# Access Compliance Report

## Public Rights-of-Way

### (Curb Ramps)

Intersection ID: N/A	Main Street: SOUTHGROVE_ST	Cross Street: WAVERLY_WALK_AV	Location: NW
ADA ID: DB5A09CFCA0A	Ramp Type: Perp	Initial Pass/Fail: Fail	Overall Compliance: No
		Severity Score: 22.5

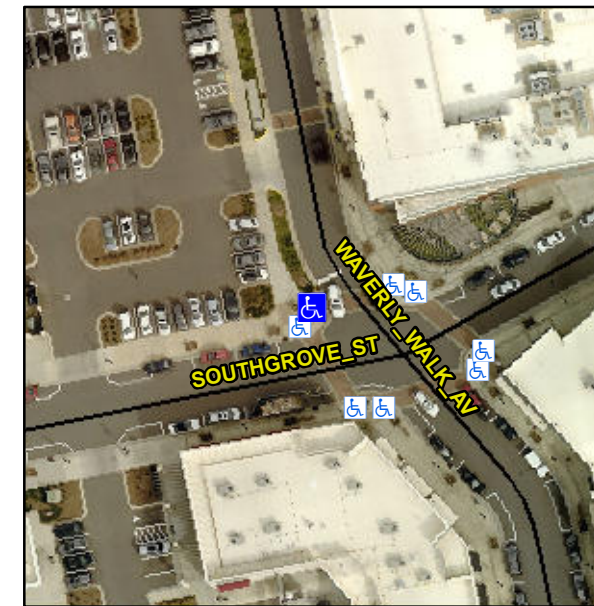
**R304.5.1, R304.2.2, R304.5.3**

Compliance	Description	Data	Compliance	Description	Data
N/A	Ramp Length (in)	98.0	No	Ramp Slope (%)	9.0
No	Ramp Width (in)	46.5	No	Ramp XSlope (%)	3.4
N/A	Flare Type LT	N/A	N/A	Flare Type RT	N/A
N/A	Flare Slope LT (%)	N/A	N/A	Flare Slope RT (%)	N/A
N/A	Flare Traversable LT?	N/A	N/A	Flare Traversable RT?	N/A
N/A	Landing Length (in)	N/A	N/A	DWS Provided?	N/A
N/A	Landing Width (in)	N/A	N/A	DWS Contrast?	N/A
N/A	Landing Slope (%)	N/A	N/A	DWS Length (in)	N/A
N/A	Landing X Slope (%)	N/A	N/A	DWS Full Width?	N/A
N/A	Landing Curb? (Y/N)	N/A	N/A	DWS Offset (in)	N/A
N/A	Shared Landing?	N/A			
N/A	Gutter Ponding?	N/A	N/A	Gutter Slope (%)	N/A
N/A	Gutter Lip Ht (in)	N/A	N/A	Gutter X Slope (%)	N/A
N/A	Painted X Walk1?	Yes	N/A	Painted X Walk2?	N/A
	X Walk 1 Direction	To E		X Walk 2 Direction	N/A
N/A	X Walk 1 Width (in)	104.0	N/A	X Walk 2 Width (in)	N/A
	X Walk 1 Slope (%)	0.6		X Walk 2 Slope (%)	N/A
	X Walk 1 X Slope (%)	0.0		X Walk 2 X Slope (%)	N/A

**Remove & Replace Entire Ramp.**
